Your Ref	SSD-66711218
Our Ref	NCA/2/2024
Contact	Douglas Bennett
Telephone	02 9806 5405
Email	dbennett@cityofparramatta.nsw.gov.au

26/08/2024

COUNCIL SUBMISSION TO REQUEST FOR ADVICE ON EIS – MIXED-USE BUILD TO RENT DEVELOPMENT (SSD-66711218) AT 33 ARGYLE STREET, PARRAMATTA

Figure 1 Proportion of bedrooms per dwelling in City of Parramatta between 1991 and 2021 (source: ABS)

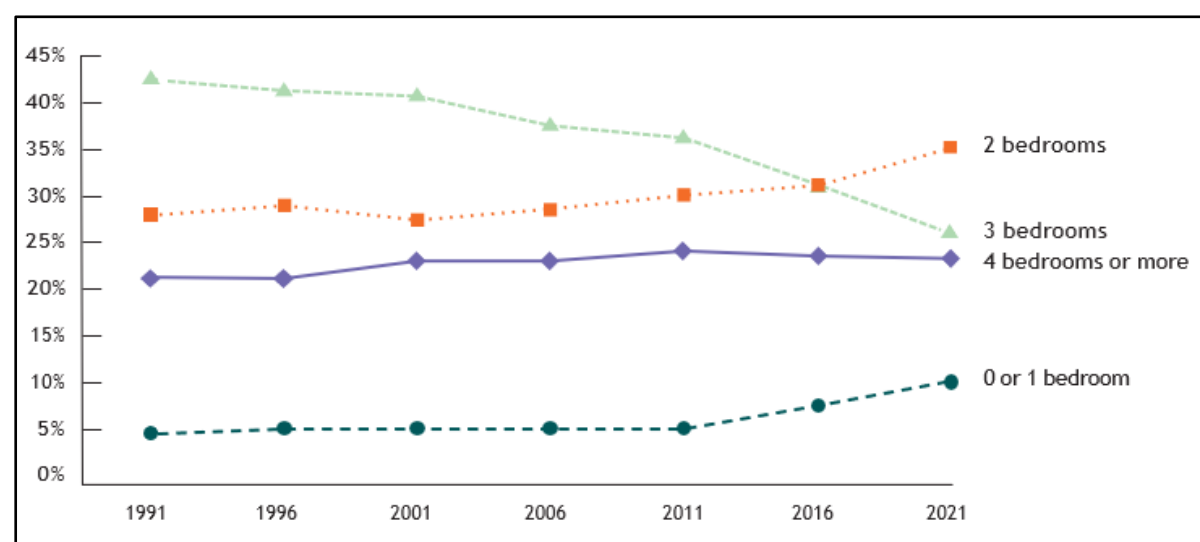
Transformations in the built form of City of Parramatta have impacted the availability of different dwelling sizes. Whilst two and three-bedroom dwellings are the dominant dwelling size in City of Parramatta, Figure 1 shows that the proportion of three and four-bedroom dwellings declined between 2011 and 2021. A gap is emerging in the availability of three-bedroom dwellings, falling from 36.5% of total dwellings in 2011 to 26.8% in 2021.

The proposed dwelling mix should consider the demographic composition of Parramatta and accommodate a range of household sizes, so that the development can effectively meet the needs of the local community.

Figure 2 Occupied dwellings by dwelling type and number of bedrooms in 2021 (source: ABS data)

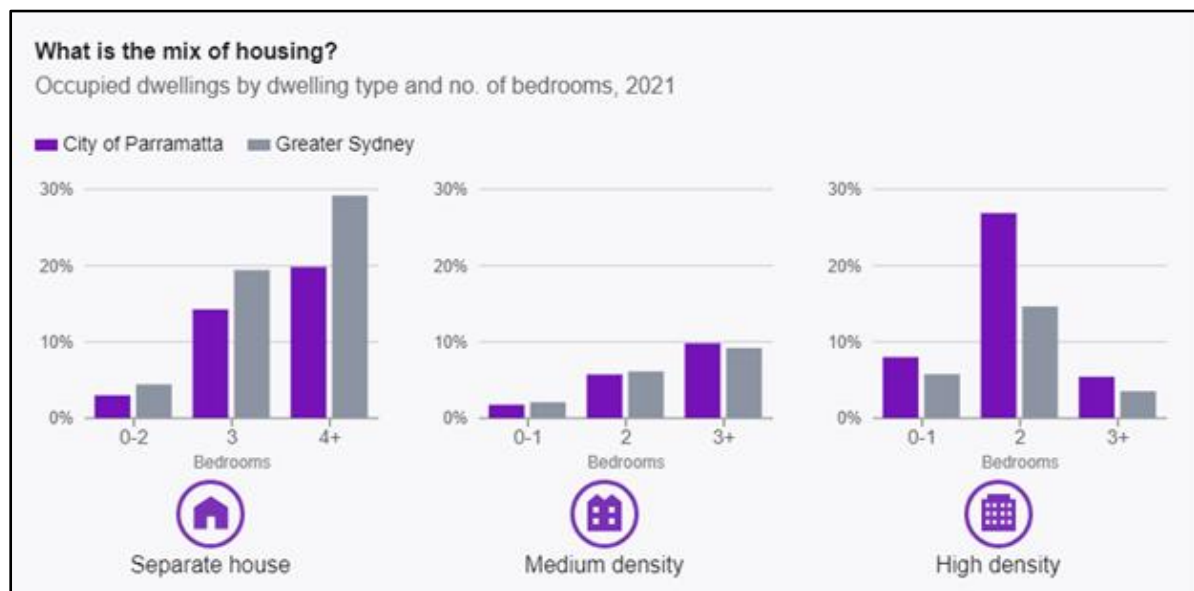
Figure 2 shows that the provision of three-bedroom dwellings in RFB developments is low. Most apartments are two-bedroom dwellings (26.9%), followed by studio/one-bedroom apartments (8%). Only 5.4% of apartments have three bedrooms or more, compared to 34.1% of separate houses and 9.8% of medium density housing.

Figure 3 Semi-recessed awning (example)

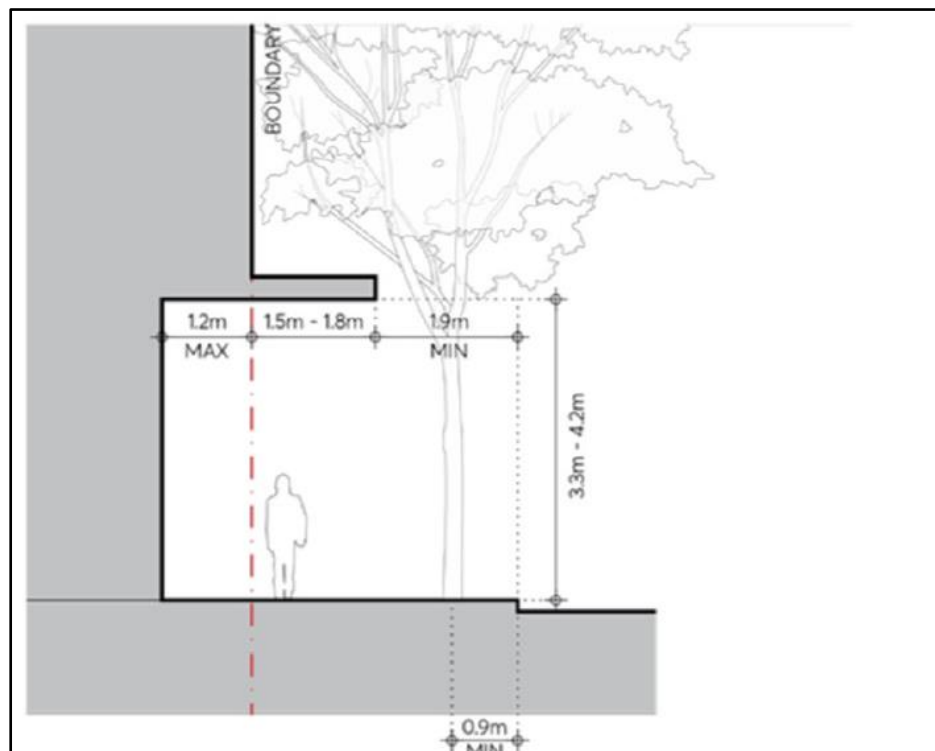
Council requests that street trees be prioritised over awnings at this site. Semi-recessed awnings should be investigated where the footpath is less than 3.9m (see figure below). Where a semi-recessed awning is proposed the awning must be integrated with the building soffit above. The space must be free of columns. The frontage must be integrated with the adjacent frontages. Any ground floor recess should be kept to a minimum if an awning is accommodated.

Figure 5 *Probable Maximum Flood*

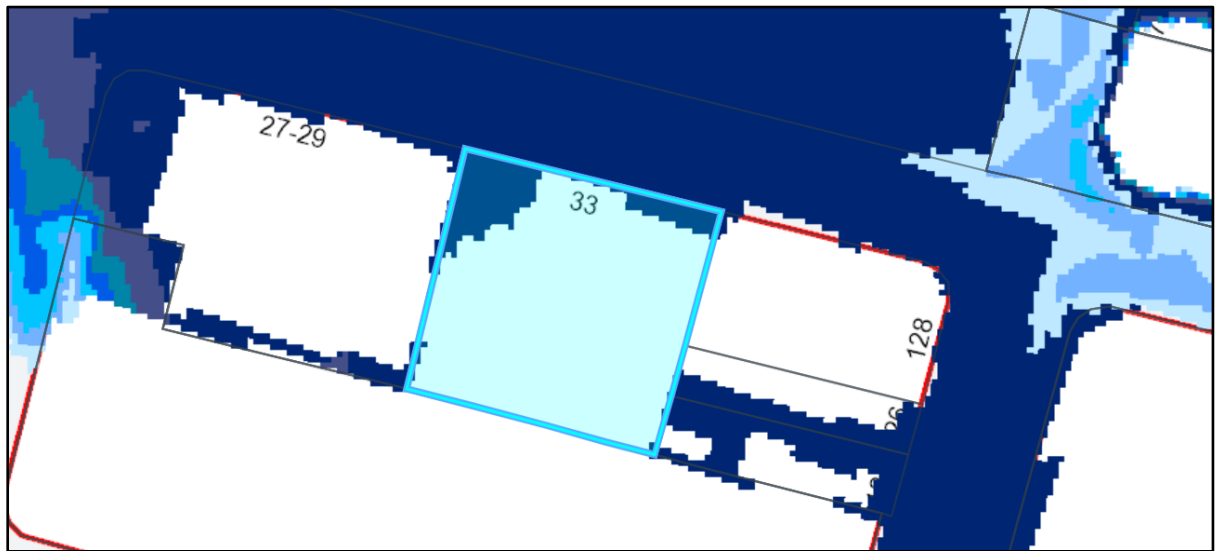
Council notes that there is no flood affectation on the site under the 1% AEP. Under the Probable Maximum Flood there is significant flood affectation in the adjoining streets but only some within the site (see figures below).

Council recommends that the proponent obtain the relevant current flood information prior to any design competition or detailed application and design the building accordingly. Shelter in place refuge should also be incorporated into the detailed design of the building.
